Access Compliance Report

Public Rights-of-Way

Intersection ID: 10038458	Main Street: SOUTHERN_PINE_BV	Cross Street: N/A	Location: NE
ADA ID: 3FC03D19ABF8	Ramp Type: PerpDiag	Initial Pass/Fail: Fail	Overall Compliance: No
Severity Score: 37.5			
Codes/Mitigation Info/Possible Solution		Field Measurements/Component Compliance

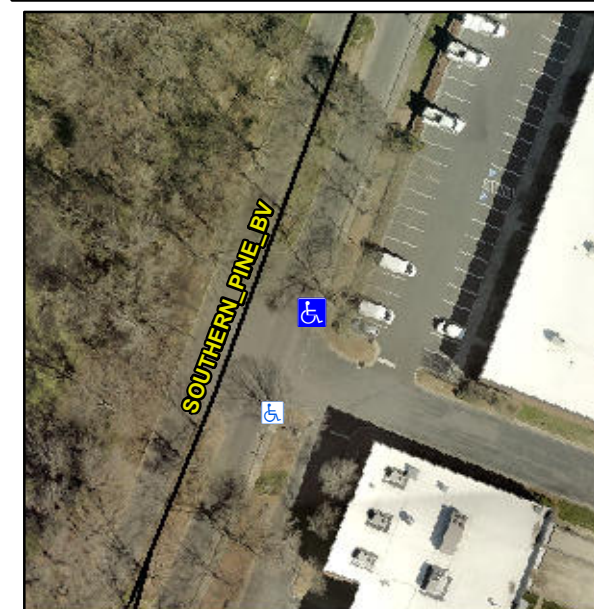
Not Found, R304.2.2, R304.5.3

Compliance	Description	Data	Compliance	Description	Data
N/A	Ramp Length (in)	44.0	No	Ramp Slope (%)	15.4
Yes	Ramp Width (in)	48.0	No	Ramp XSlope (%)	5.5
N/A	Flare Type LT	N/A	N/A	Flare Type RT	N/A
N/A	Flare Slope LT (%)	N/A	N/A	Flare Slope RT (%)	N/A
N/A	Flare Traversable LT?	N/A	N/A	Flare Traversable RT?	N/A
N/A	Landing Length (in)	N/A	N/A	DWS Provided?	N/A
N/A	Landing Width (in)	N/A	N/A	DWS Contrast?	N/A
N/A	Landing Slope (%)	N/A	N/A	DWS Length (in)	N/A
N/A	Landing X Slope (%)	N/A	N/A	DWS Full Width?	N/A
N/A	Landing Curb? (Y/N)	N/A	N/A	DWS Offset (in)	N/A
N/A	Shared Landing?	N/A			
N/A	Gutter Ponding?	N/A	N/A	Gutter Slope (%)	N/A
N/A	Gutter Lip Ht (in)	N/A	N/A	Gutter X Slope (%)	N/A
N/A	Painted X Walk1?	No	N/A	Painted X Walk2?	No
	X Walk 1 Direction	To W		X Walk 2 Direction	To S
N/A	X Walk 1 Width (in)	N/A	N/A	X Walk 2 Width (in)	N/A
	X Walk 1 Slope (%)	4.6		X Walk 2 Slope (%)	2.5
	X Walk 1 X Slope (%)	0.8		X Walk 2 X Slope (%)	8.3

Remove & Replace Curb Ramp With Two New Directional Ramps or Equivalent.
